SEA and SEA quality vegetation map

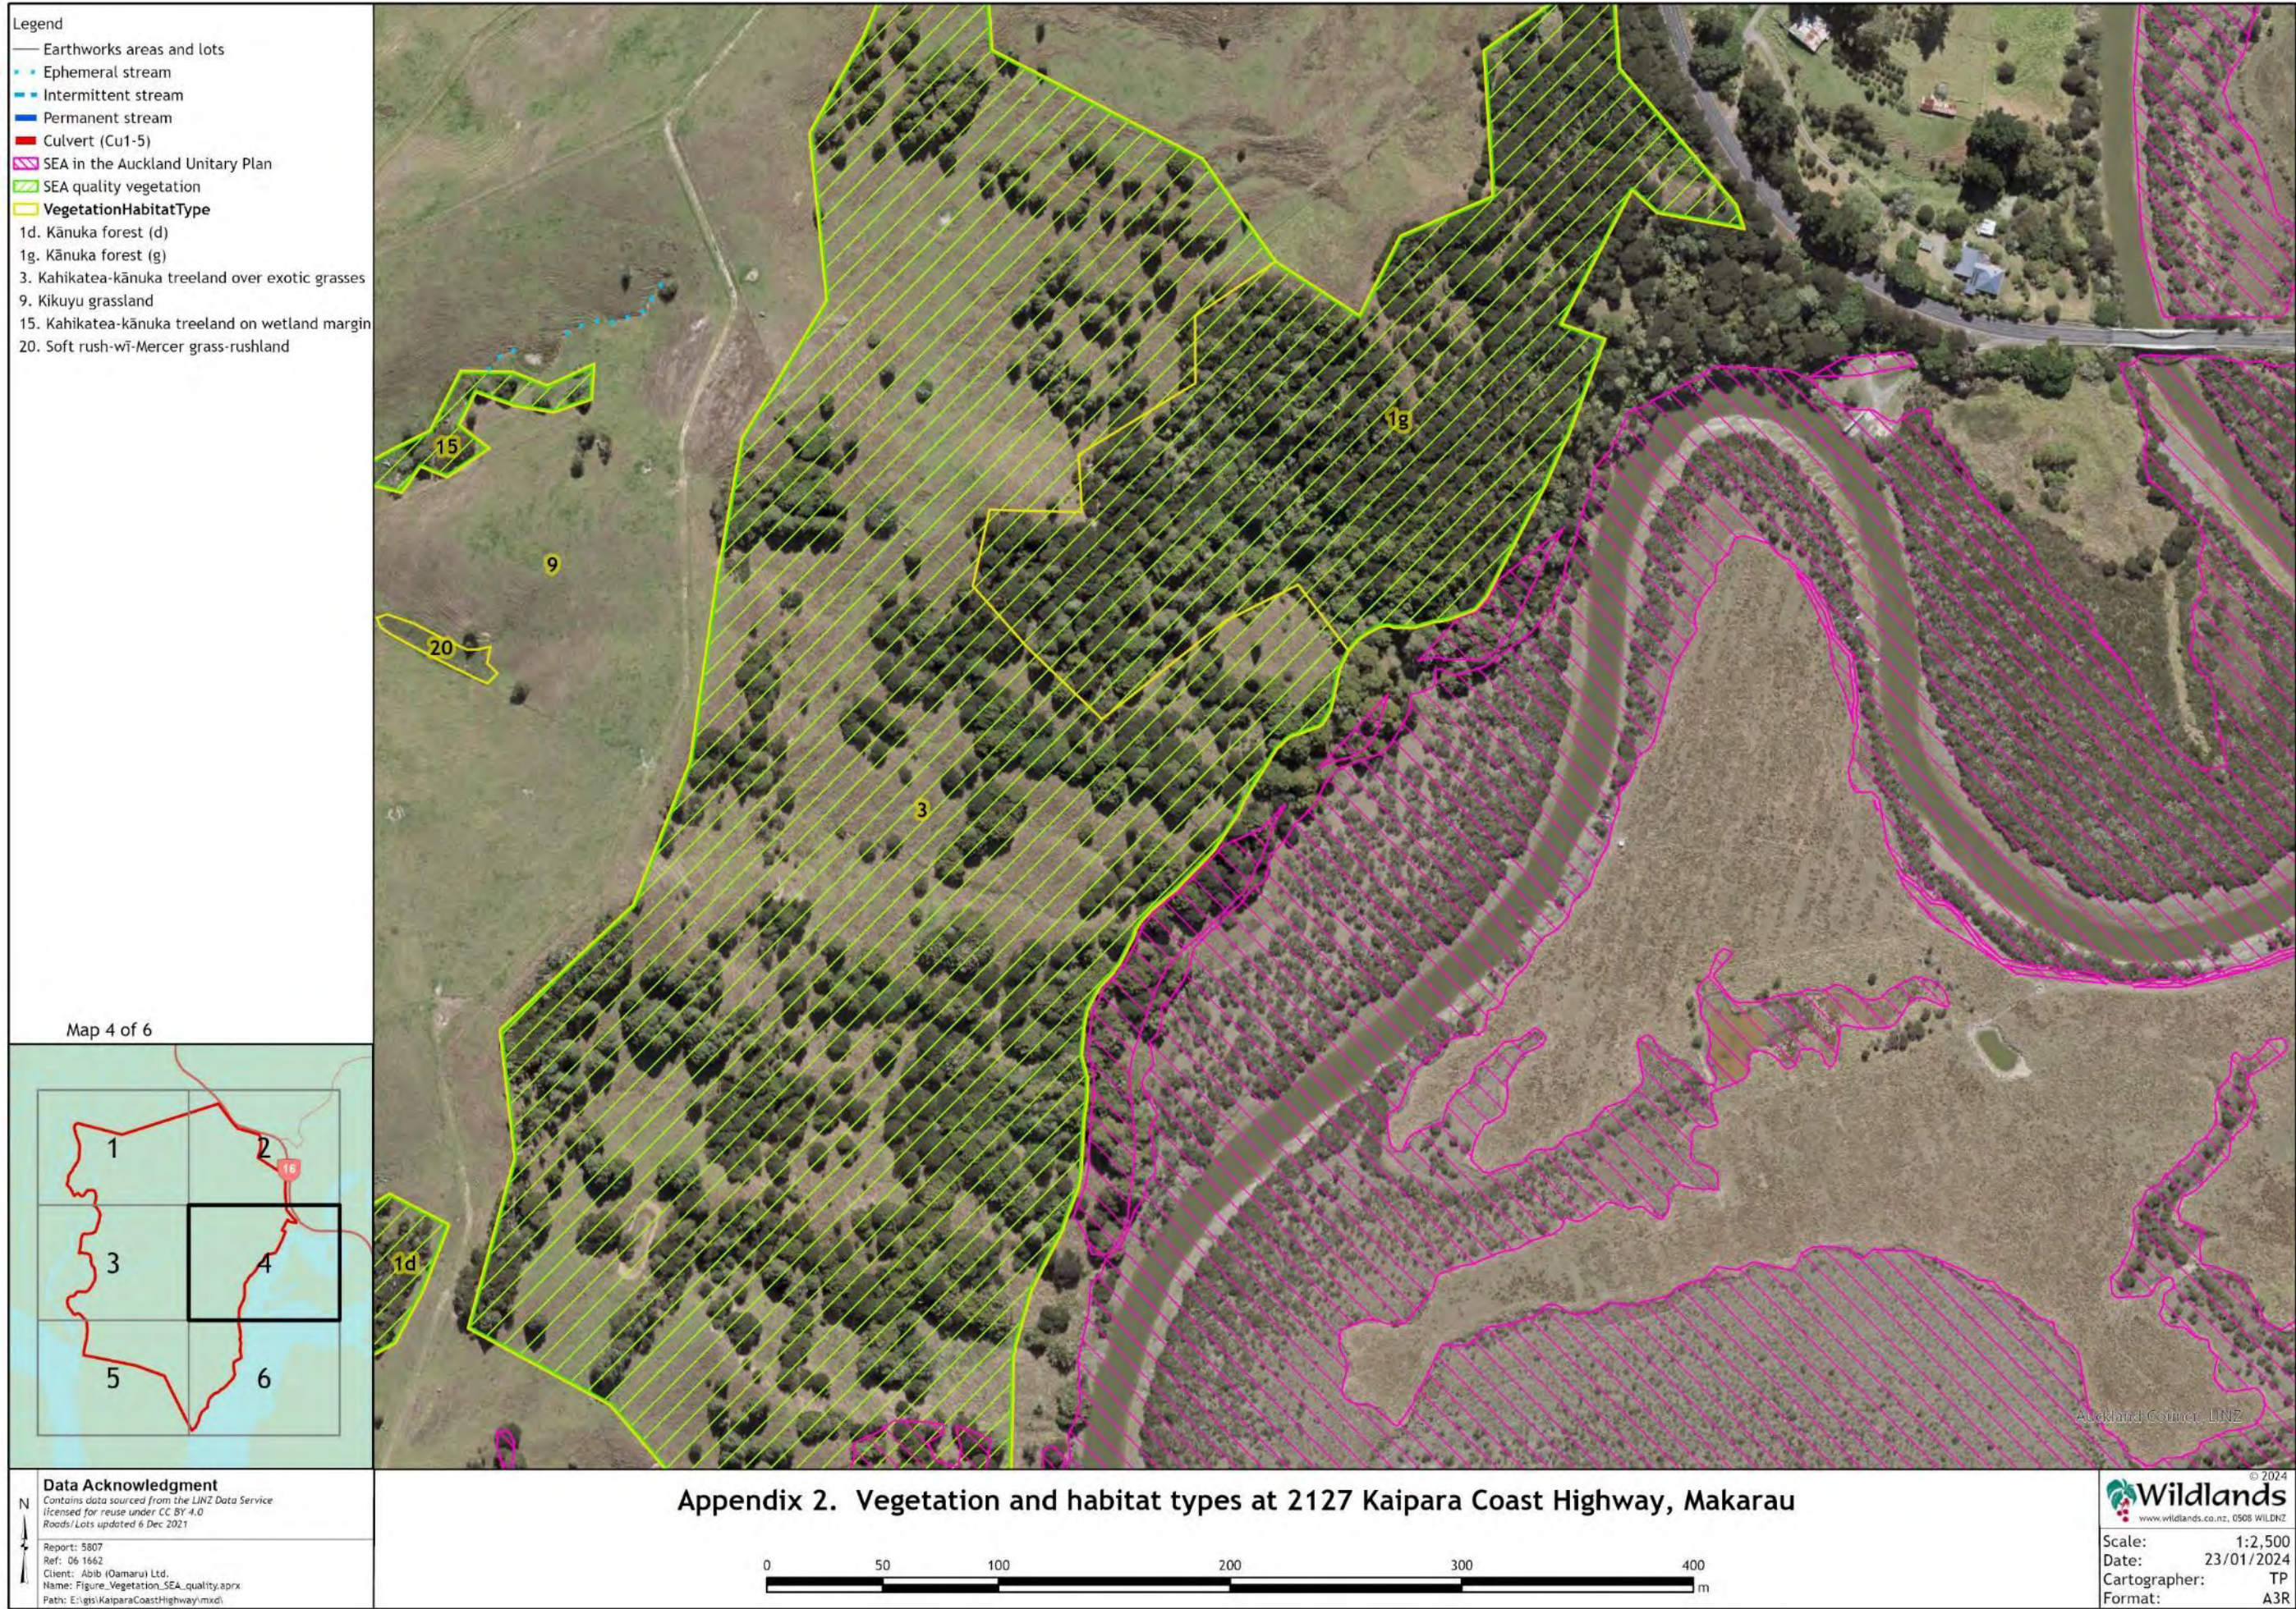
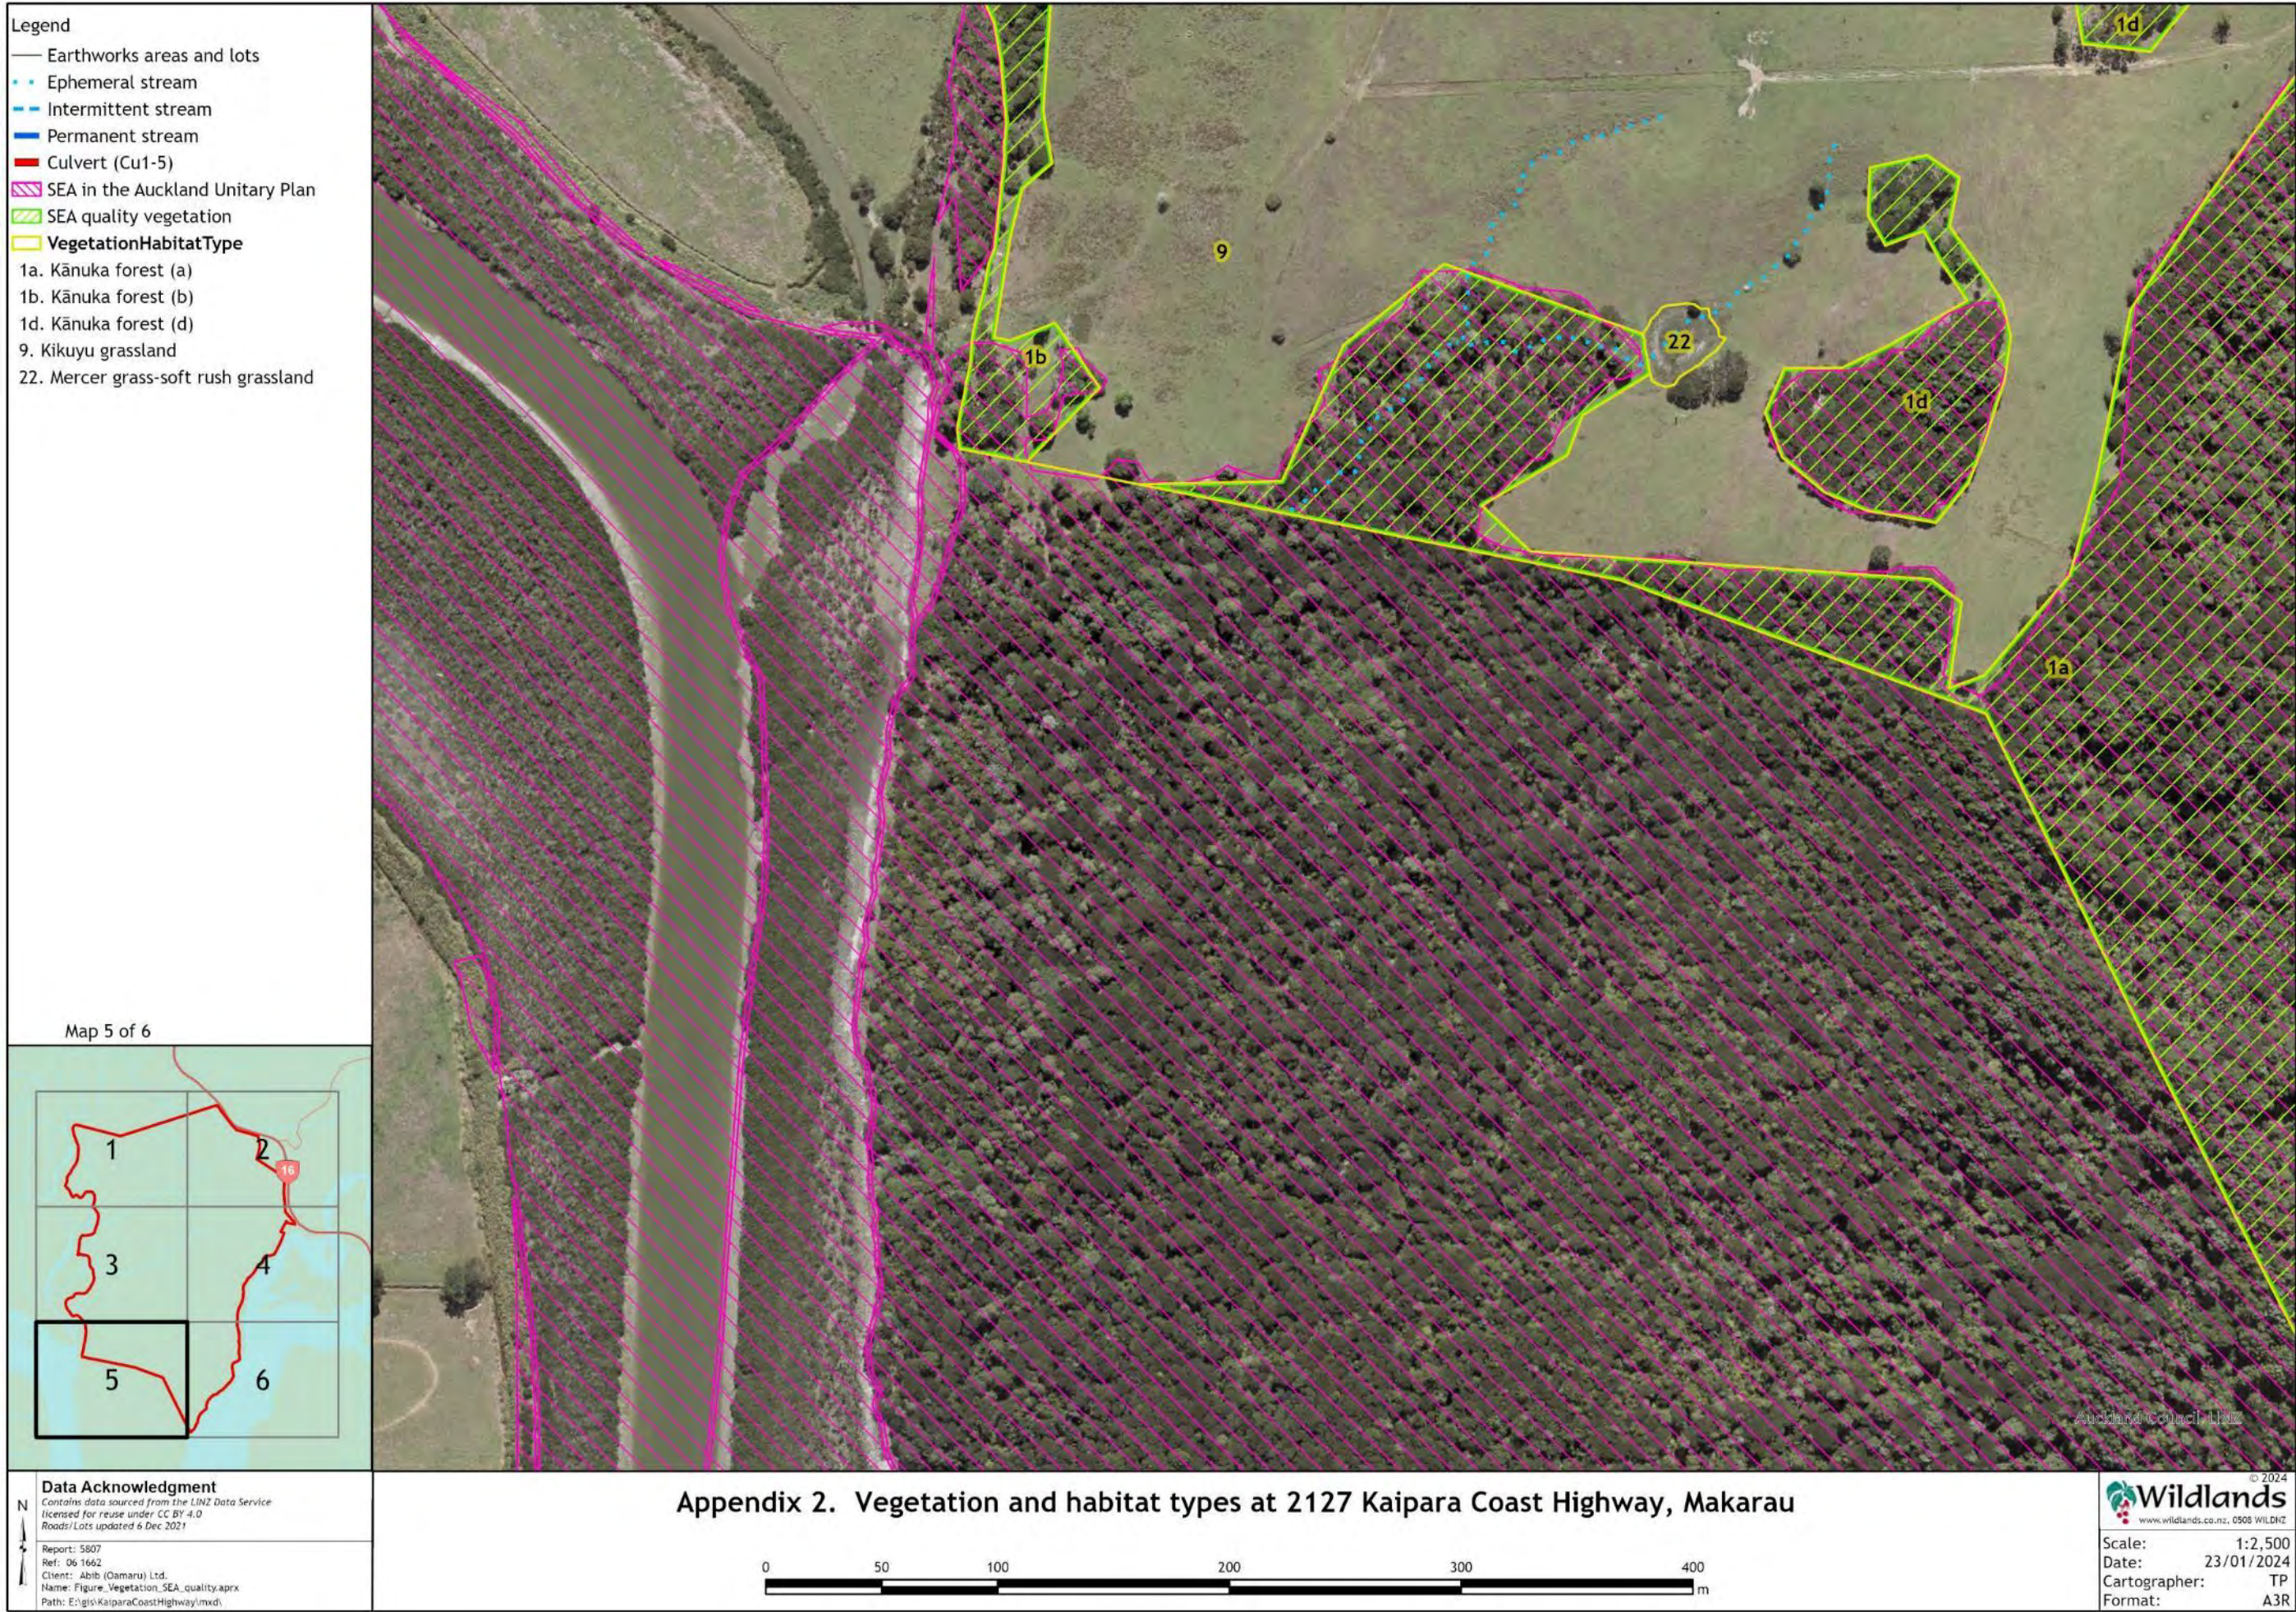
- 1.47 *A plan is requested as per E39.6.1.6 clearly identifying SEA areas and other areas of indigenous vegetation, wetlands, and watercourses on site.*

- 1.48 *Please provide an assessment of areas of vegetation proposed for protection that are already identified as SEA or areas meeting the factors for Significant Ecological Areas in Policy B7.2.2(1) and confirm the areas (m2) each of the areas within the site cover.*

“The maps provided in the original Ecological Impact Assessment (EclA) have been updated to include the SEA overlay and any areas that are of ‘SEA Quality’ (Appendix 2). As outlined in the EclA, this includes all areas of forest, treeland, and scrub at the site as they are likely to provide habitat for indigenous fauna species that have been classified as ‘Threatened’ or ‘At Risk’ (Factor 2b: Threat status and rarity). These fauna habitat values are discussed in more detail in Section 6 of the EclA. These vegetation types also form part of a network of sites that cumulatively provide important habitat for indigenous fauna (Factor 4c: Stepping-stones, migration pathways and buffers).

All natural inland wetland areas that are dominated by indigenous plant species also meet the criteria to be classified as SEA (Factor 2d: Threat status and rarity) and have therefore been mapped accordingly (Appendix 2).
